St. Johns River Water Management District

February 22, 2011

Re: North Hancock Road Widening (Segment A); Application Number 40-069-50126-4
(Please reference the above name and number on all correspondence)
Formerly Application Number 42-069-50126-4

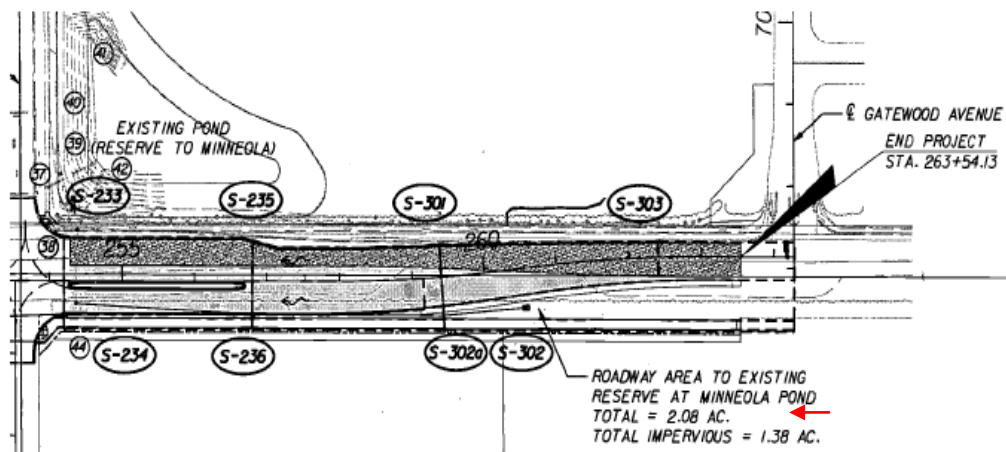
- a. The information provided on page 3 of the *Stormwater Management Report* submitted states, in part “*Basin #4 From North of Fosgate Avenue to Project End (Stations 256+80 to End of Project): The runoff from the roadway is to be collected and directed into the existing pond (NODE 30) within The Reserve at Minneola subdivision. The SJRWMD permit number for this subdivision is 4-069-92447-1. The total area allowed in the pond from Hancock Road is 2.341 acres of which 1.288 acres can be impervious area. Based upon the proposed improvements of Hancock Road, only the runoff from station 256+90 to the end of the project can be accommodated for in this pond. The total area discharging to the pond is 1.85 acres of which 1.26 acres is impervious.*”

Please note that the above information appears to be inconsistent with the post development drainage basin map delineated on *Sheet No. 4* of the set of construction plans submitted, which indicates that the total area discharging to the pond is 2.08 acres, of which 1.38 acres is impervious. Reference the following excerpt of the drainage basin map.

Accordingly, please clarify and revise where appropriate, for accuracy with the proposed condition.
